Our Reference: 284402

REF: 242066

Ascot House, Finchampstead Road, Wokingham, RG40 2NW
Consultee Response Note

Figure 5 - Roof Access Scaffold System West Elevation

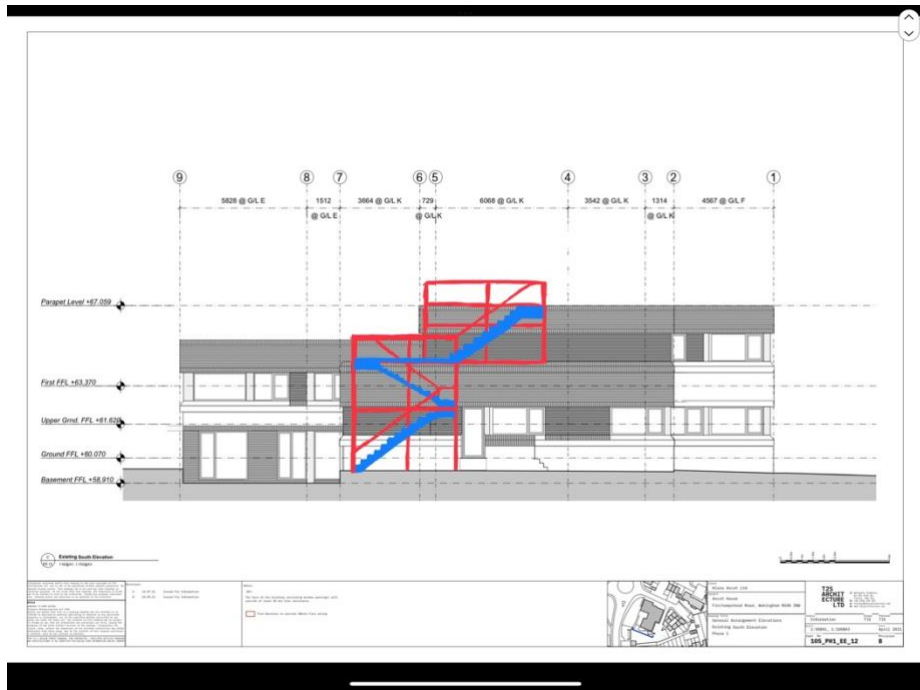
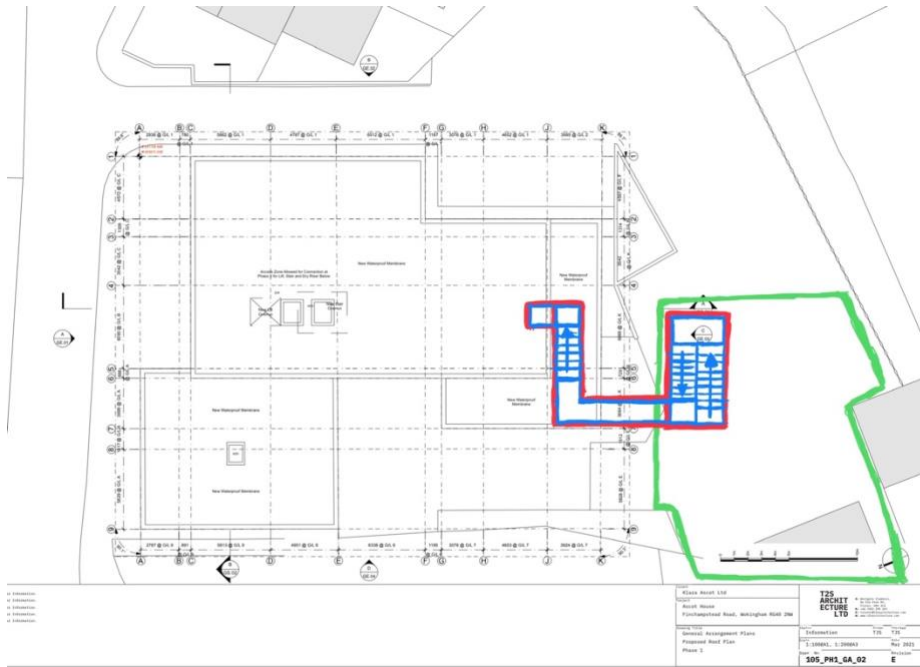
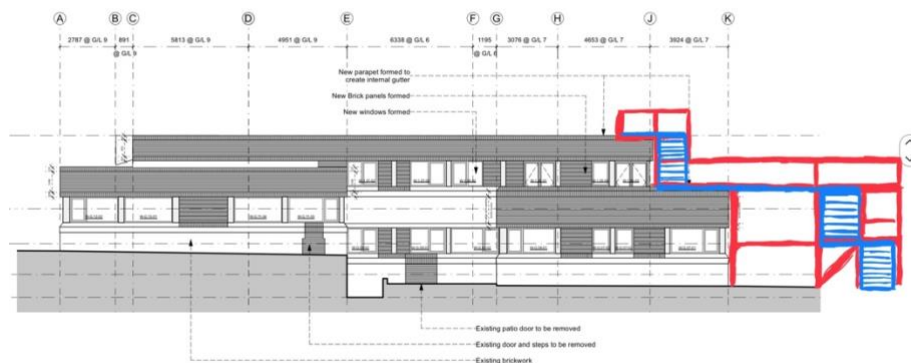
As outlined below in **Figures 3-5**, construction access will be via a scaffold tower which will house an access staircase, this will be fully enclosed to avoid any overlooking from site personnel into any apartments if required. The access frame will be located adjacent

the southern elevation of the building in a position designed to not obstruct the windows of apartments, this may require a stand-alone stair tower and bridge access on to the roof area subject to detailed investigations by contractors if a suitable location cannot be identified. See initial sketches below showing the access tower and bridge which is positioned to avoid any windows.

DRAWING TITLE
PROPOSED GROUND FLOOR PLAN
AS EXISTING

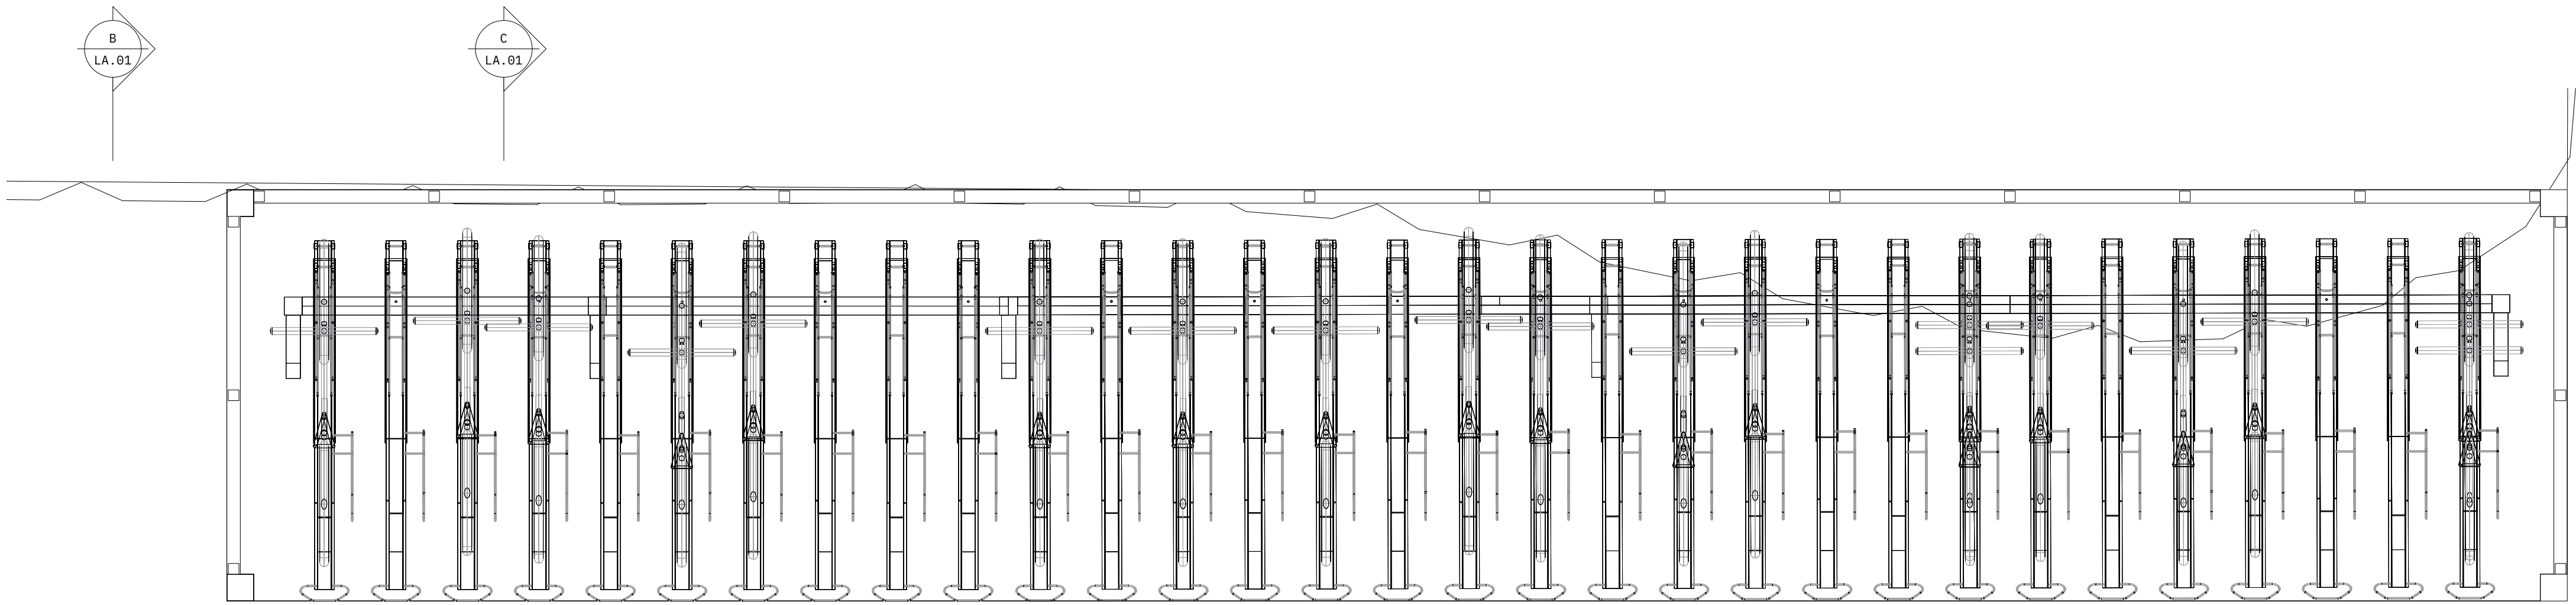
- 4) *"It is not clear on the site plan where the cycle parking will be located. This needs to be shown."*

Applicant Response: The cycle store is shown located adjacent to the SW corner of the building along the western boundary of the site. Please refer to the following drawings at **Appendix I** for further details:

Client
Klara Ascot Limited
Project
Ascot House
Finchampsted Road,
Wokingham RG40 2NW
Drawing Title
Proposed Cycle Store

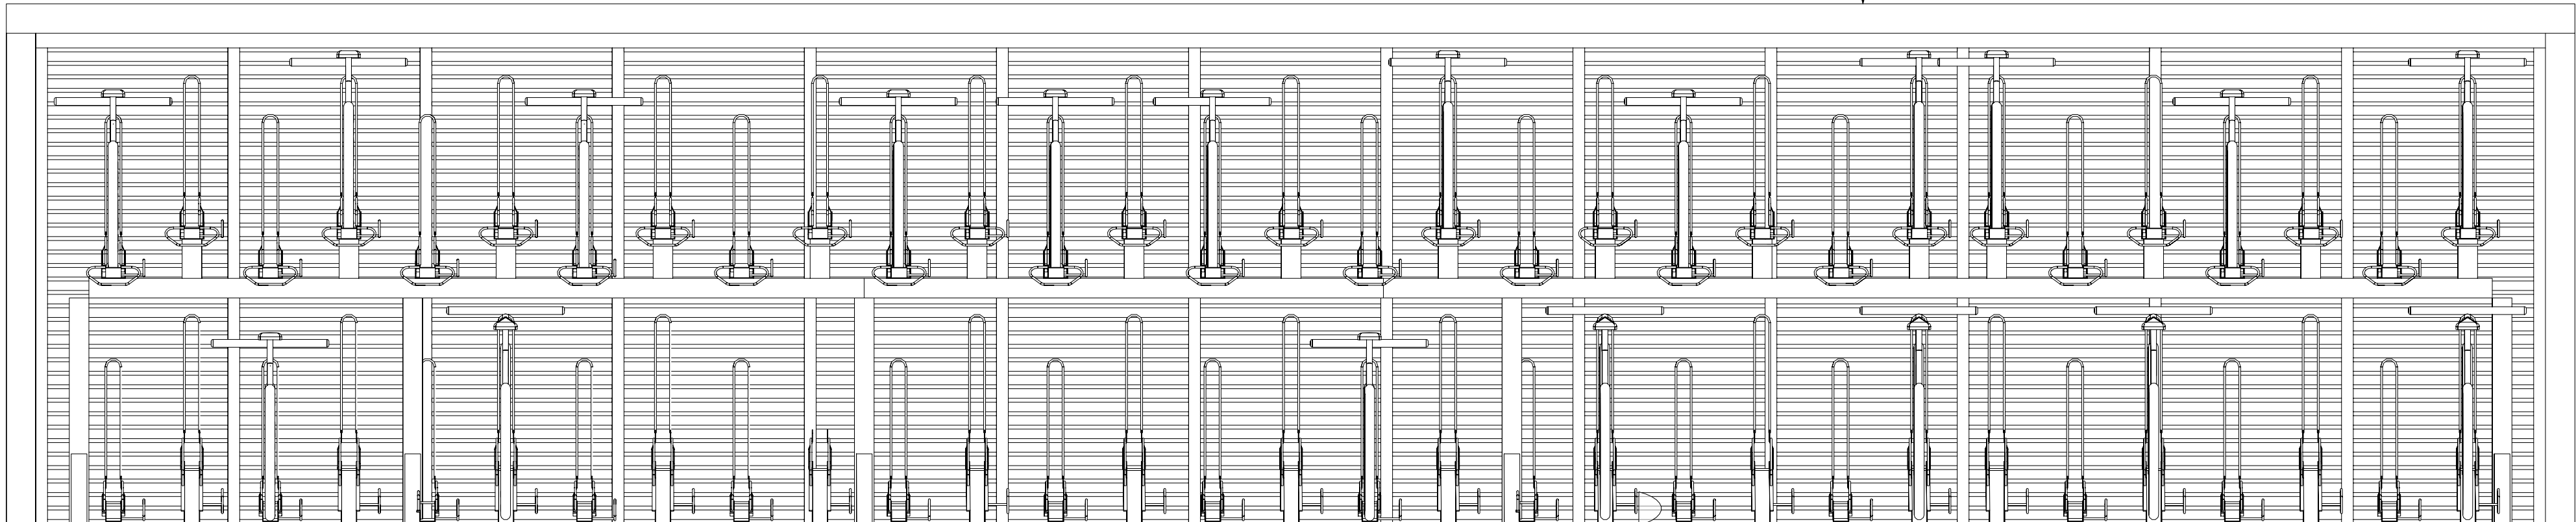
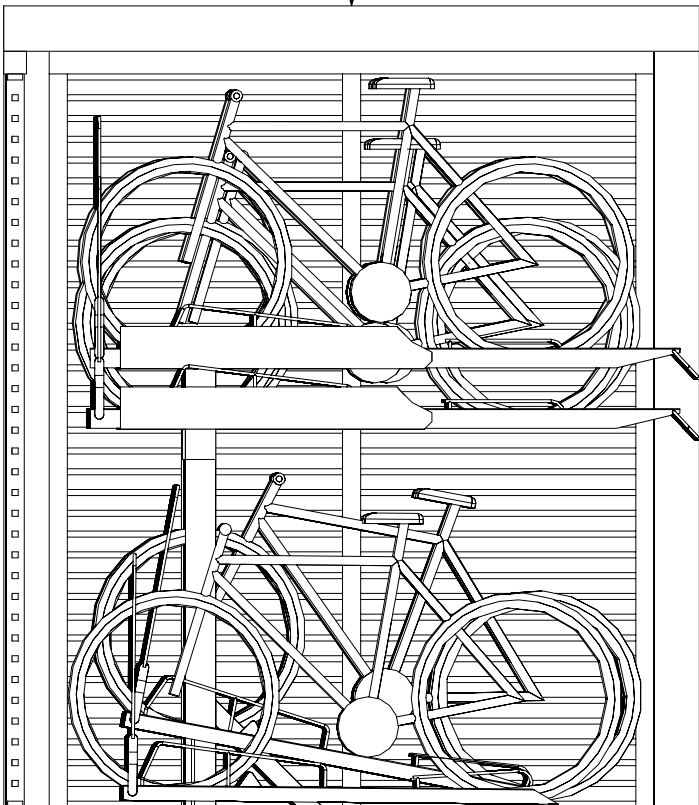
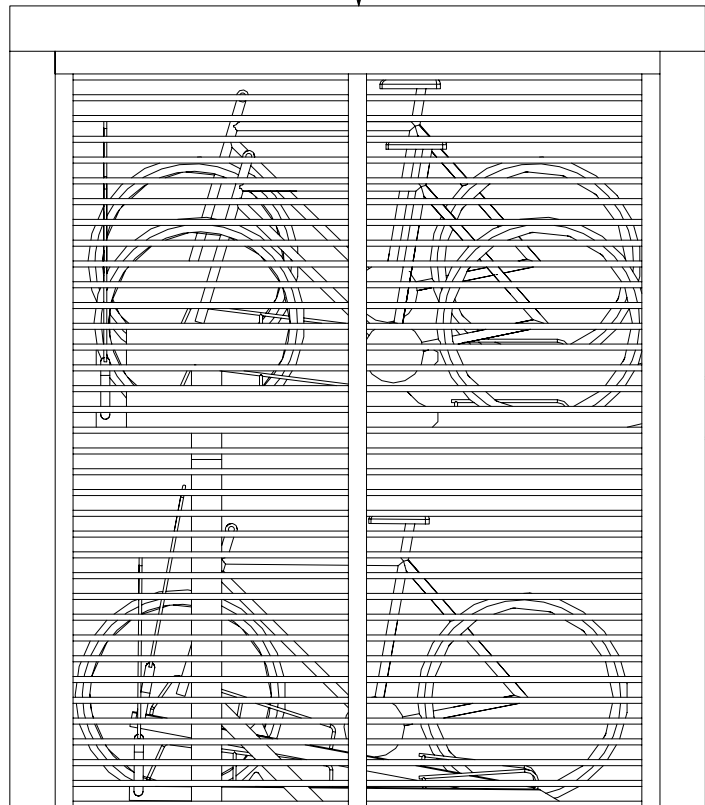
- 5) *"Highways is content to secure the details of the cycle parking through a planning condition."*

Applicant Response: Details of the cycle store have been provided with the application therefore we do not consider it necessary to impose a planning condition. Please refer to the following drawing at **Appendix I** for further details:

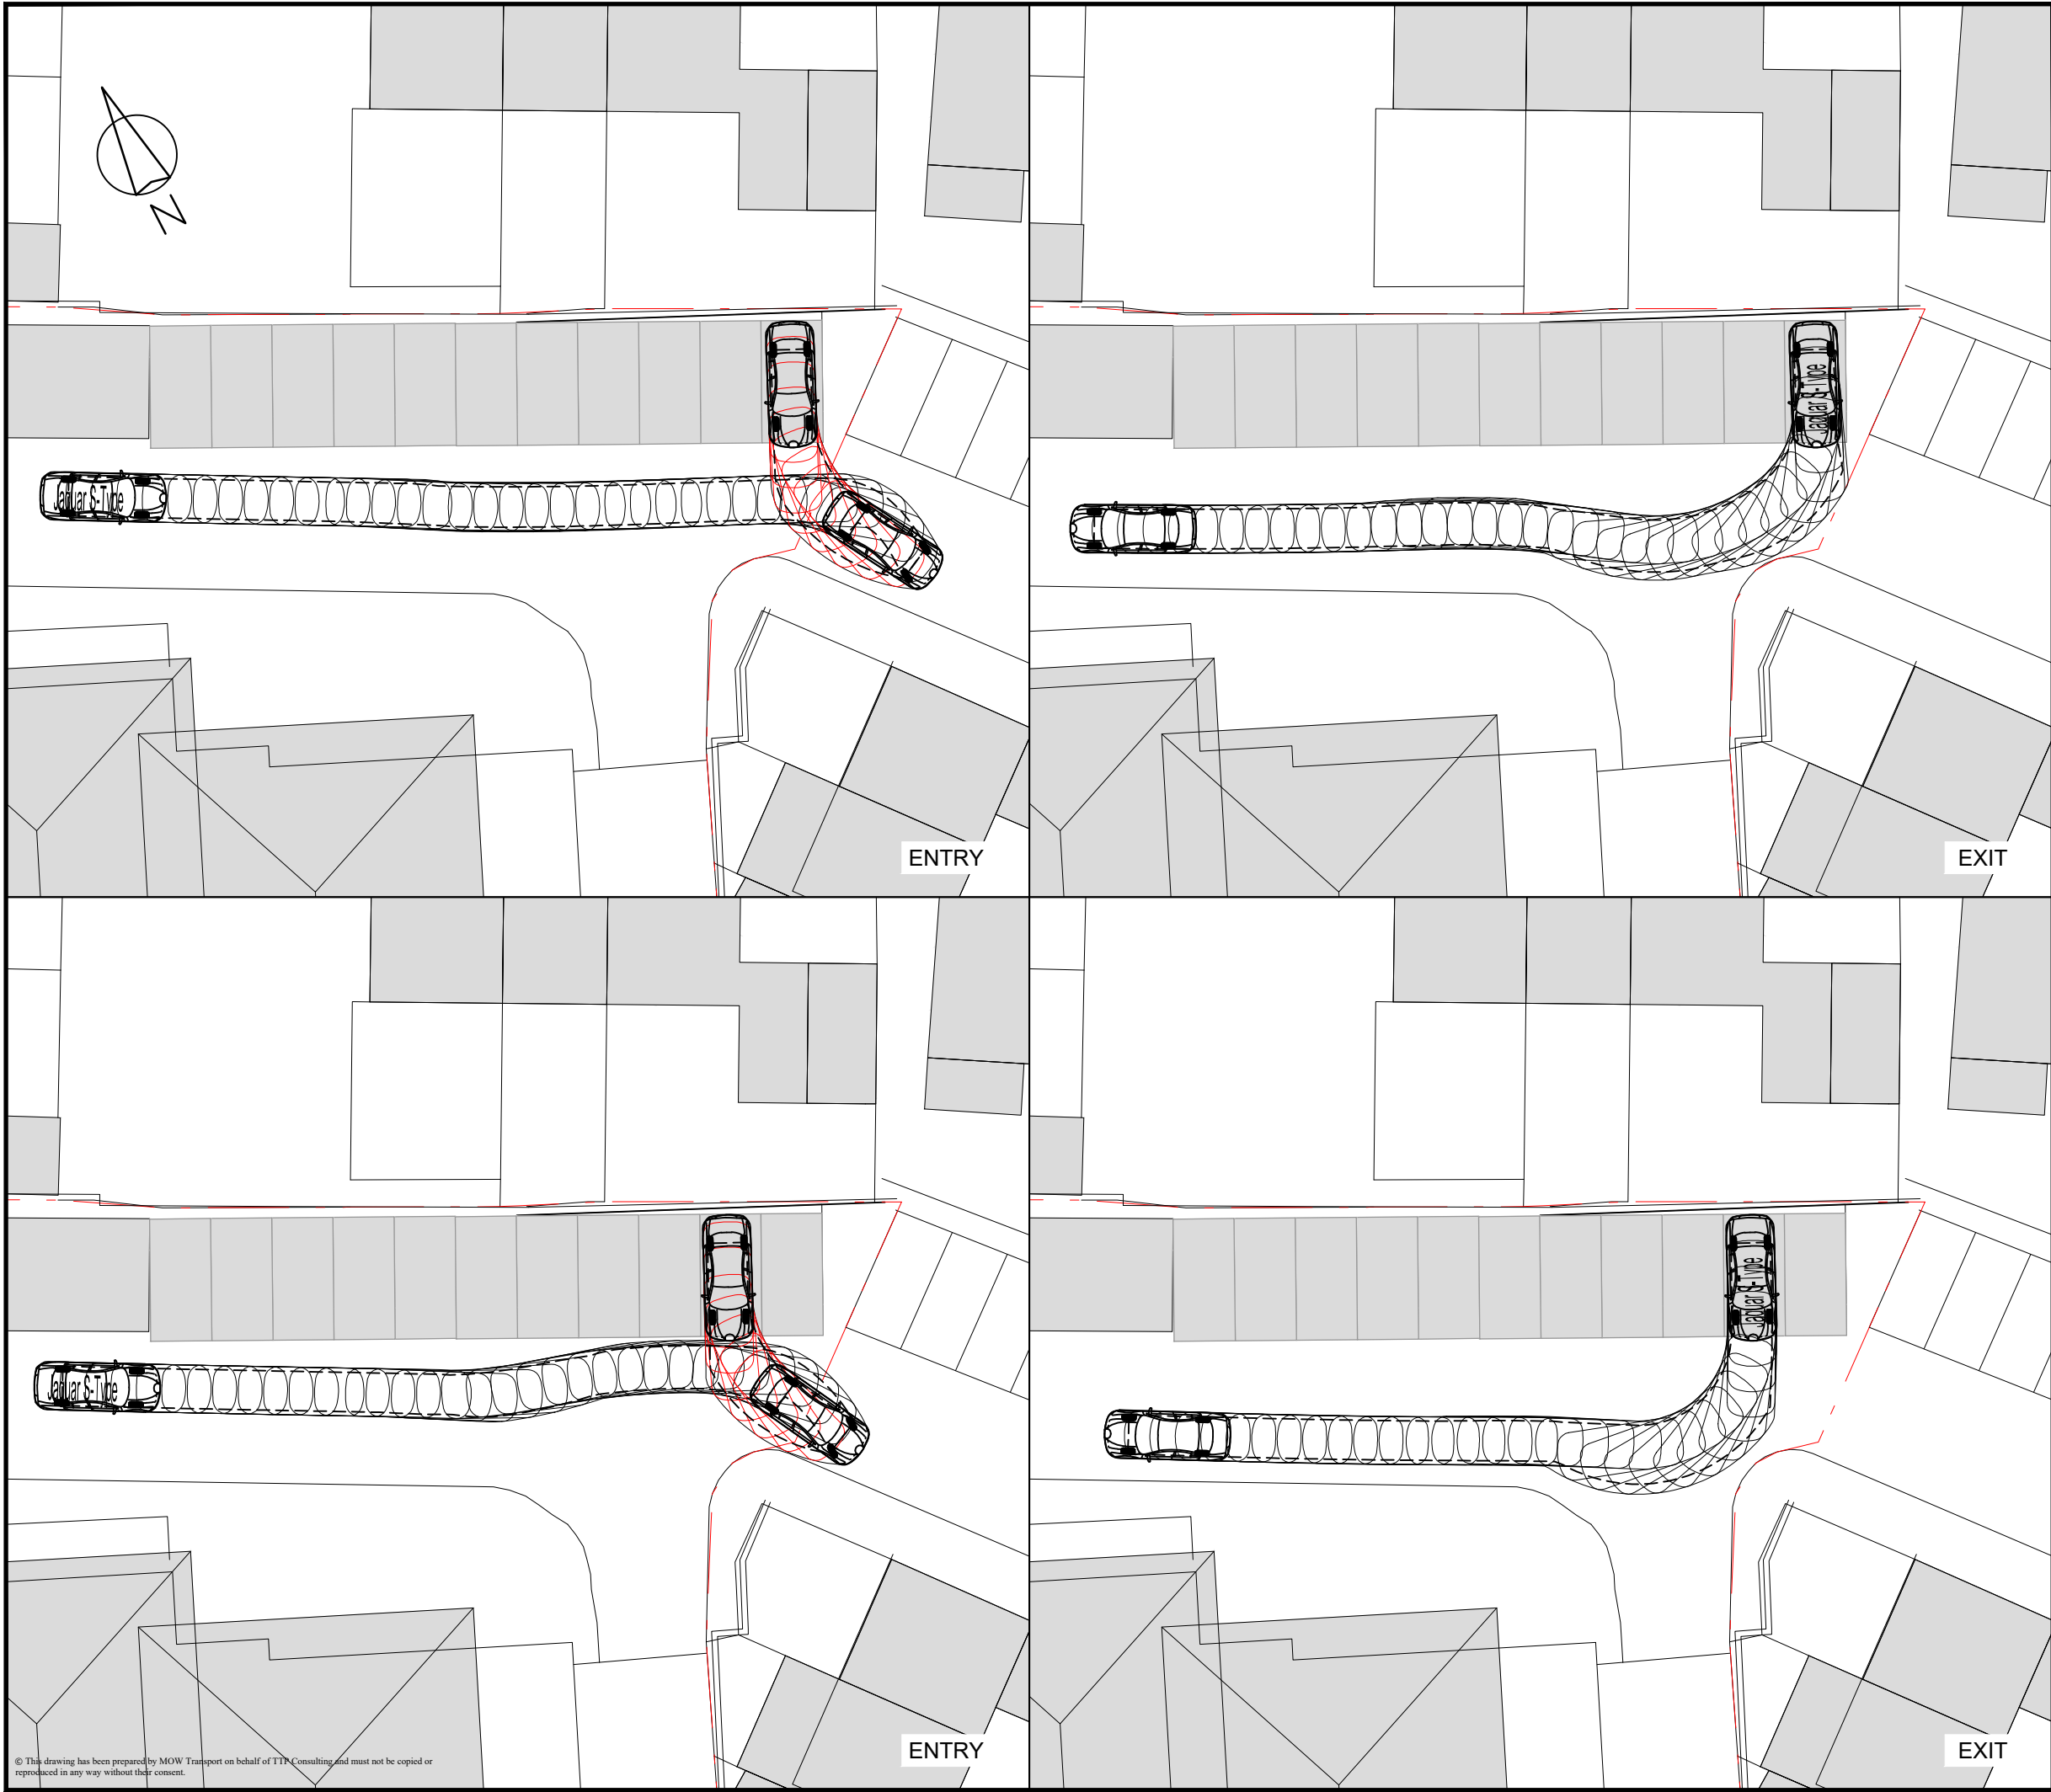
- 6) *"Swept paths of a large car have been submitted showing that vehicles can access and egress the spaces for these 10 flats safely which is welcome. However, these have been based on current parking layout and should have been carried out on the parking spaces that have been included in the Construction Management Plan and recommended as permanent by highways."*

Applicant Response: Please refer to updated drawing 'Swept Path Analysis using a Large Car' (dwg ref. no. 2020-3964-AT-109) provided at **Appendix I** which demonstrates acceptable turning radii for large cars along the amended northern boundary parking layout.
